February 9, 2012
U7-C-NINA-NRC-120013
10 CFR 2.390

South Texas Project
Units 3 and 4
Docket Nos. 52-012 and 52-013
Response to Requests for Additional Information

RAI 09.01.02-9**QUESTION:**

RAI 09.01.02-17**QUESTION:**

Figure 7: Original Acceleration Time History – X Direction (Horizontal)

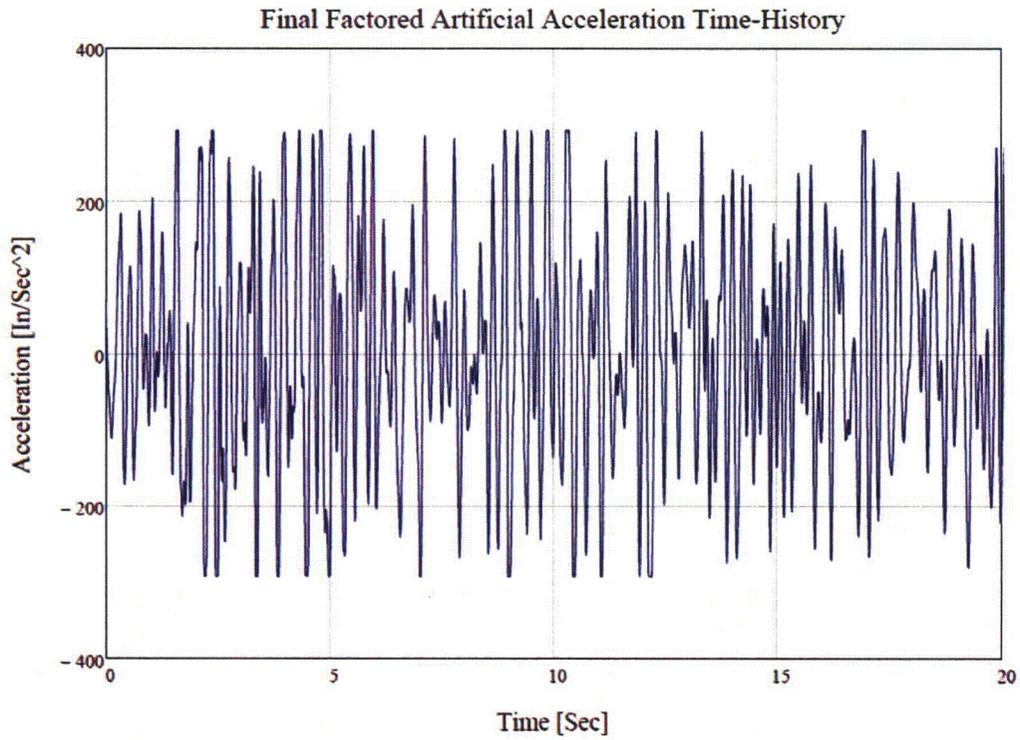
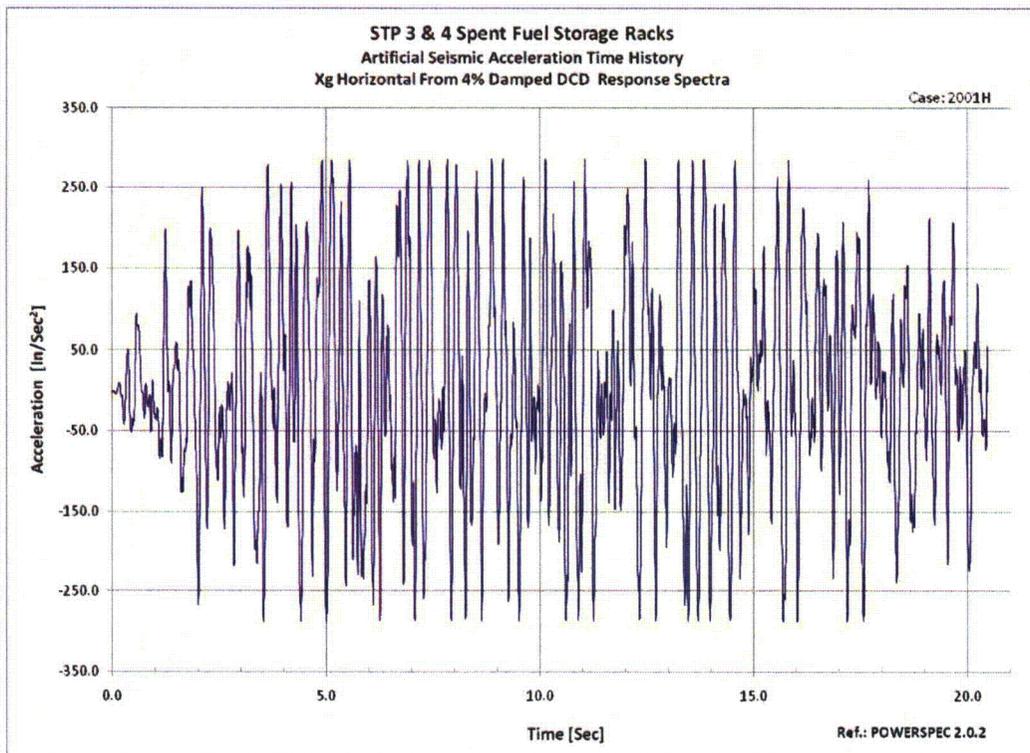
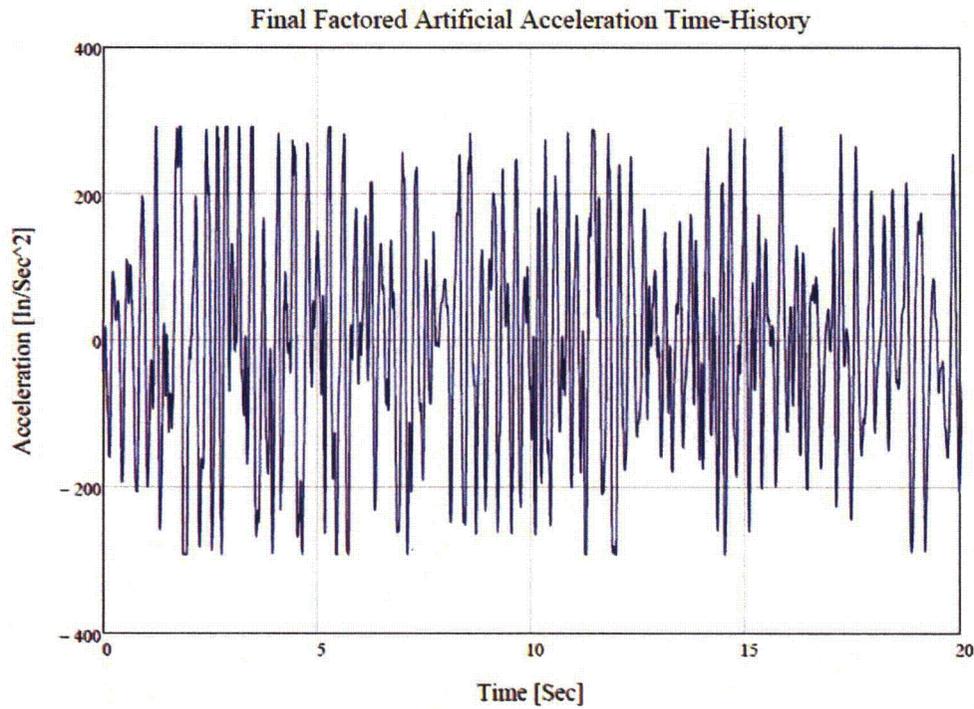
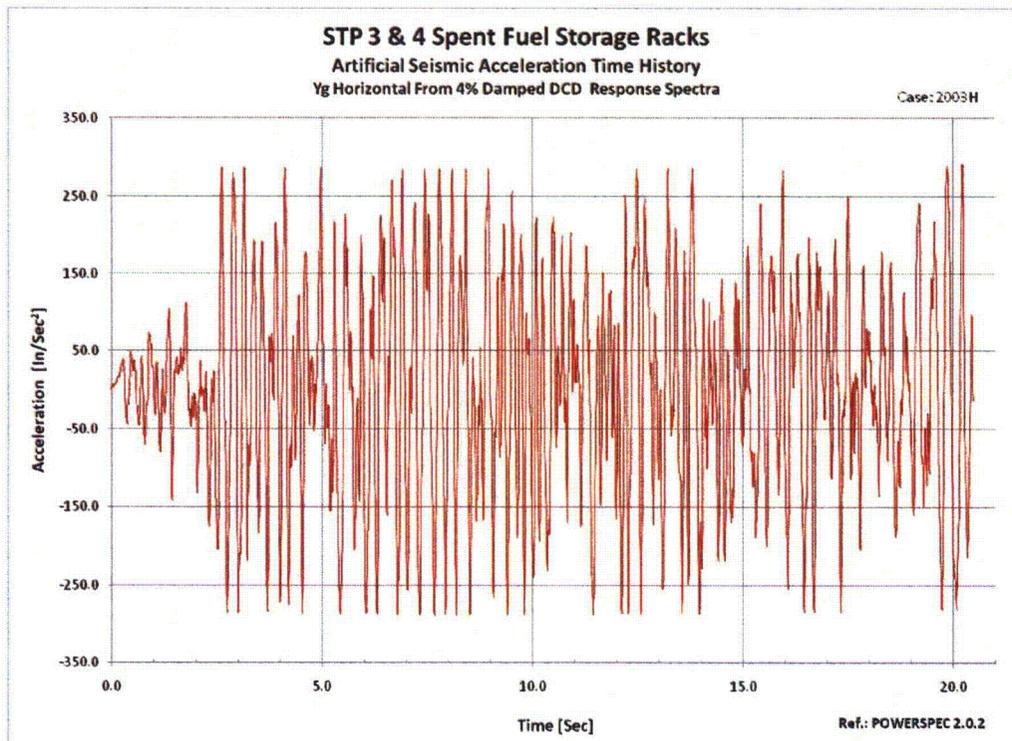
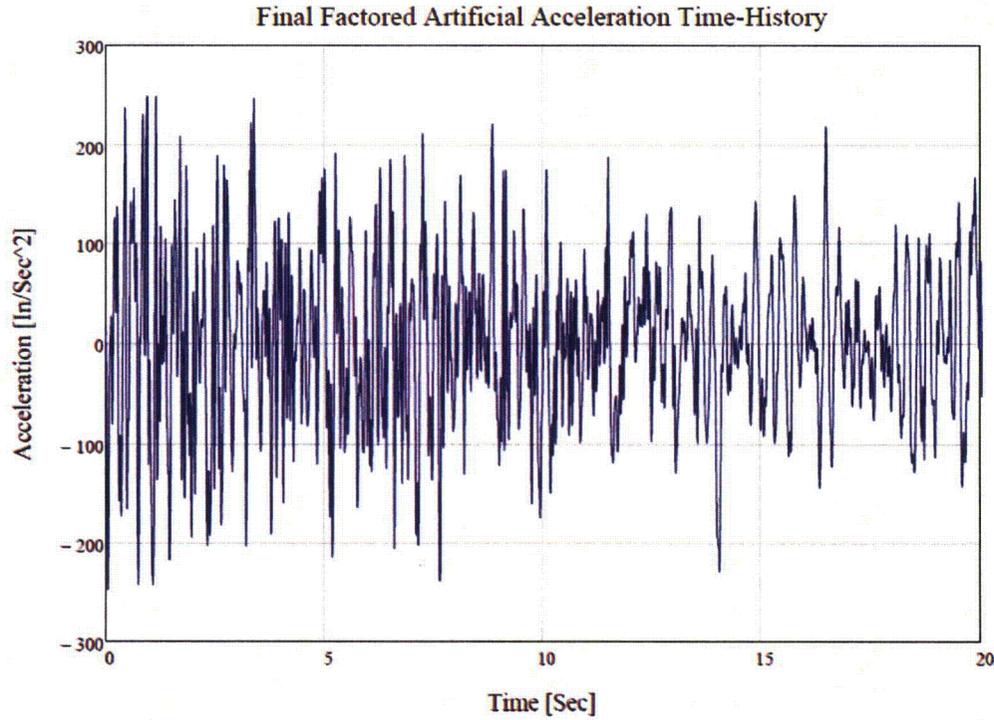
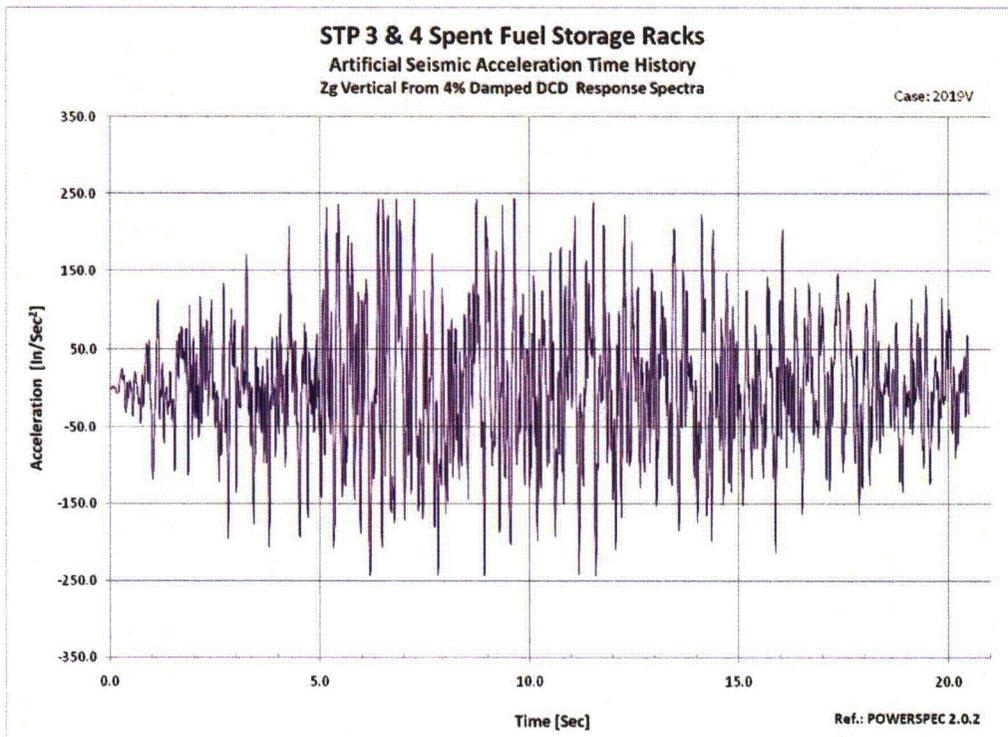
- d. The plots of the horizontal synthetic time histories presented in Figures 4-2 and 4-3 of the Technical Report exhibit the characteristic that there are many acceleration peaks up to the target spectrum ZPA. It appears that these time histories are derived from traces that had higher acceleration peaks, and all the higher peaks were reduced to the ZPA. Consequently, the synthetic time histories do not look like earthquake time traces. Please explain the process used to develop the horizontal synthetic time histories, and provide the technical basis for their adequacy.

The process used to generate the artificial time histories is the same process used by Westinghouse to generate artificial time histories for the AP1000[®] PWR spent fuel rack licensing effort. This approach yielded results that meet the requirements of NUREG-0800, SRP 3.7.1 as described in the response to c. above. The methodology uses a MathCAD spreadsheet to perform an iterative calculation, which converts a starting recorded earthquake ground motion, in this case the El Centro earthquake, to a time history with a calculated response spectrum that closely matches the target input seismic response spectrum. If, during an iteration, the acceleration exceeds the specified Zero Period Acceleration (ZPA), the worksheet automatically lowers the value to the ZPA (also known as “clipping”). This is a standard part of the methodology, and results in synthetic time histories that closely match the target response spectra. The resulting time histories (design-basis time histories) are used in the design and analysis of the spent fuel racks.

As part of the response to the RAI, Westinghouse created a second set of artificial time histories, using an alternative method, for the sole purpose of confirming the adequacy of the original time histories used in the fuel rack analysis. The alternative method of producing artificial acceleration time histories is a mathematical approach of overlapping sine waves. This approach is available in PowerSpec 2.0.2 software. This software tool provides limited control of the ramp in and out of the strong motion portion of the event; however, there is less control over the matching of the calculated response spectrum (therefore, results may include overly conservative peaks in acceleration at any number of frequency points within the spectrum). A number of test cases were evaluated. These curves did have the classic appearance (i.e., ramp in and ramp out) and did not require “clipping” to maintain ZPA. Two successive integrations of the artificial acceleration time histories produce velocity and displacement time histories that did not exhibit “drift” and therefore does not require baseline or “drift” correction. This alternate method produced very similar results compared to the first (MathCAD) method. A comparison of acceleration time history results are included in Figures 7 through 12. For additional comparison, as further discussed in part f., a single rack model was run, with input generated from both the design-basis time histories and the second set of time histories. These results are also very similar, which confirms the adequacy of the design-basis time histories.

In summary, the design-basis time histories were created using the same methodology as that accepted for the AP1000[®] PWR spent fuel rack seismic analysis, and they satisfy the acceptance criteria as provided in NUREG-0800, SRP 3.7.1. To confirm these original time histories, a second set of time histories was created using an alternative method. The second set of time histories closely matches the originals, and test runs using input from both time histories provide similar results. Therefore, the design-basis time histories are confirmed to be acceptable.
